Release Note of Intercom V1.4.71

Firmware: V1.4.71 build 20170515

Software: V2.6.1.58 build 20170506 (Customization version based on software baseline V2.6.1.6)

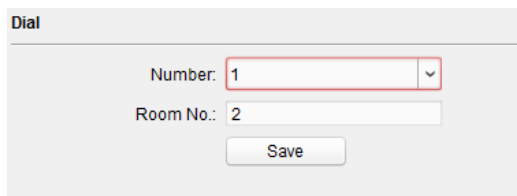
2. Single button villa door station DS-KV8102-IM/DS-KV8102-IP/DS-KV8102-VP could configure room No.;

Dial

Number: 1

Room No.: 2

Save
